Planning Commission Issues Report

Subject: Rezoning Issues Report

Petition: **P.Z. 03-2010 Suburbia Gardens (40-Timberlake SE, LLC)**

Stock and Associates, on behalf of 40-Timberlake SE, LLC, is requesting a change of zoning from “FPNU” Flood Plain Non-Urban District to a “PC” Planned Commercial District for an 8.7 acre tract of land located on the southeast corner of the intersection of South Outer 40 Road and Timberlake Manor Parkway.

PRELIMINARY PLAN W/ FLOOD STUDY
 SUBURBIA GARDENS REDEVELOPMENT

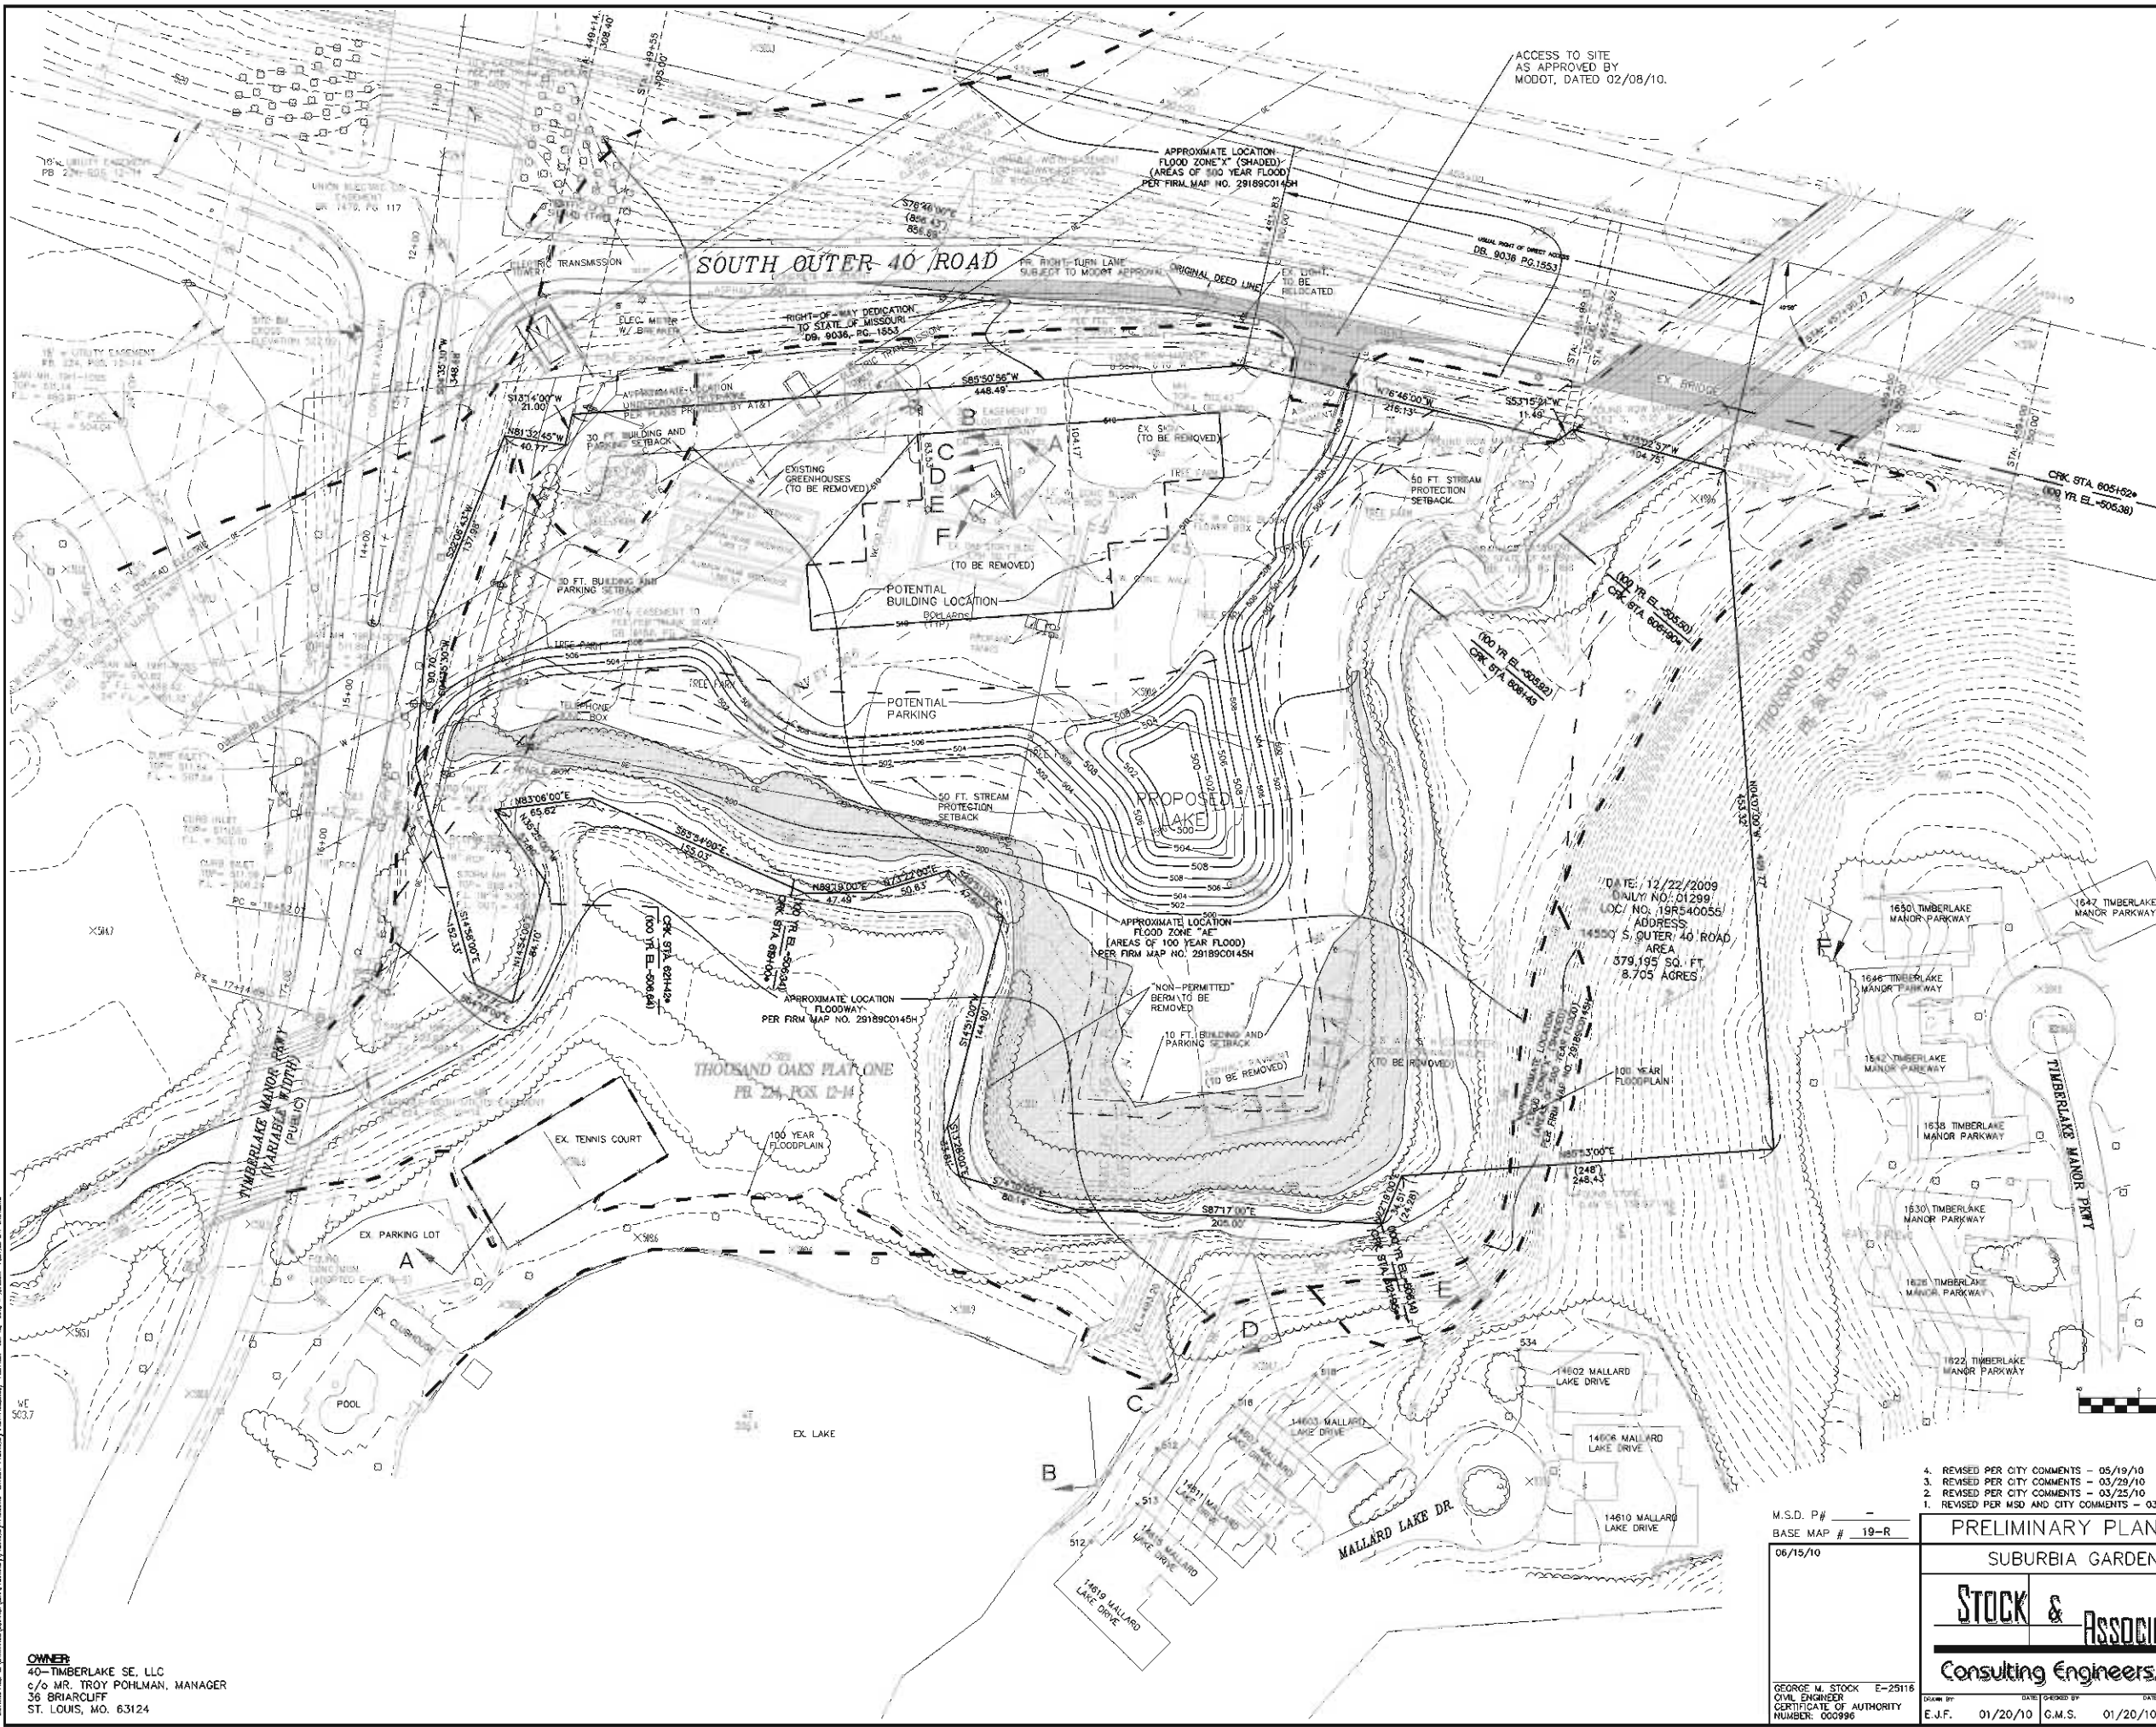
- a. Due to the relatively small depth to the site, is the entrance throat length going to meet Access Management Standards?
 - b. How is circulation on the site going to be addressed for the Fire Protection District due to the potential height of the building?

- c. Remove the Flood Plain Study Cross Sectional Lines from the Preliminary Plan.
 - d. Please clarify the location of the required fifty (50) foot stream buffer on the Preliminary Plan. There are notes and arrows that do not appear to point to any line that indicates the stream buffer location.

- e. The Preliminary Plan currently shows proposed parking within the required thirty foot landscape buffer location along South Outer 40 Road. Please amend the plan.

- 13.) Typical proposed hours of operation for General Office and Medical Office are:
6:00 a.m. to 8:00 p.m. – Monday thru Friday
8:00 a.m. to 3:00 p.m. – Saturday
Nursing Homes are typically open seven (7) days a week.
- 14.) See Revised Preliminary Plan.

- 1.c.) Ten feet (10') from the fifty feet (50') stream buffer setback on the southern and western sides of the development, as shown on the attached Preliminary Plan.
